# CITY OF PORTLAND, MAINE

## PLANNING BOARD

Project Name: **Mixed Use Development at 321 Commercial Street (corner Maple Street)**  
Project ID: 2012-615 CBL: 40-E-3  
Address: 321 Commercial Street  
Applicant: J B Brown & Sons  
Planner: Jean Fraser

Submitted to: Portland Planning Board Public Hearing Date: January 22 <sup>nd</sup> , 2013	Prepared by: Jean Fraser, Planner Date: January 18 <sup>th</sup> , 2013 <b>Planning Board Report # 02-13</b>
-----------------------------------------------------------------------------------------------	--------------------------------------------------------------------------------------------------------------------

The two plans below compare the original submission to the final proposal:

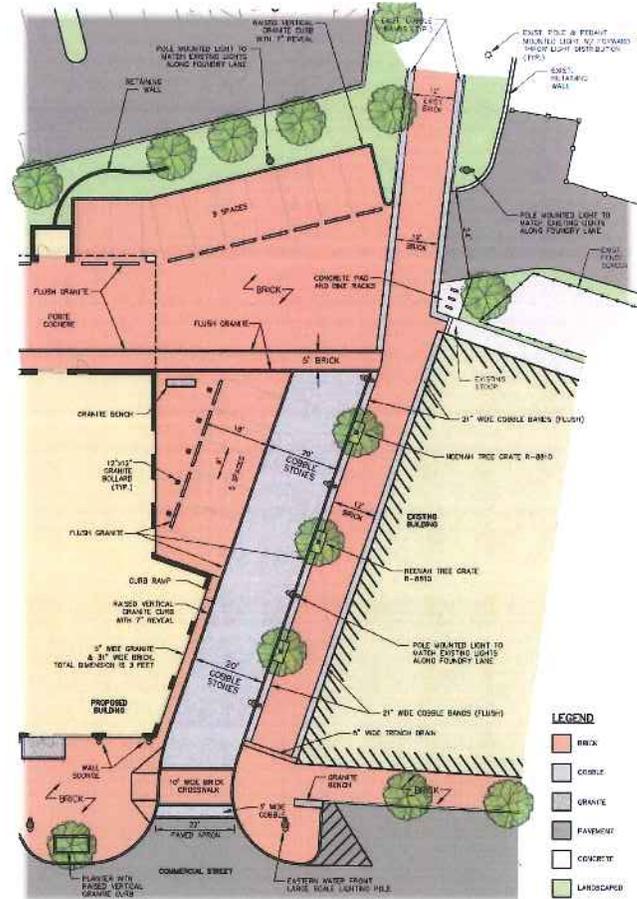
The two Workshop Memos have detailed the discussions and comments on the layout for this area, which focused on achieving a wide pedestrian walkway that continued the existing walkway, ensuring a safe integration of pedestrians and vehicles, and addressing historic preservation objectives. The final layout at right has been approved by the Historic Preservation Board on 1.16.2013 and is acceptable in terms of site plan standards.
